SERVICE BULLETIN

APPLICABILITY: 2012-19MY Legacy and Outback
 2014-16MY Impreza
 2014-17 Crosstrek
 2012-18MY Forester
 2014-19MY WRX and WRX STI

NUMBER: 07-152-19R

SUBJECT: Power Window Switch Changes

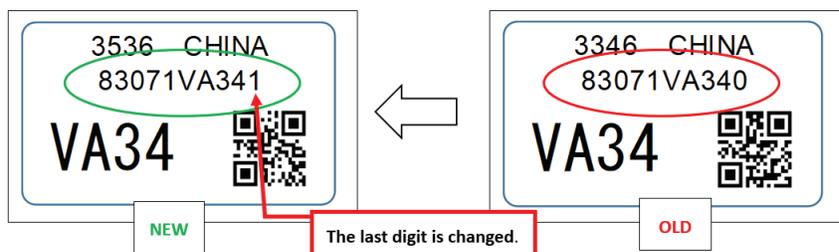
Use the part number on the label to distinguish between the old and new switches as shown below:
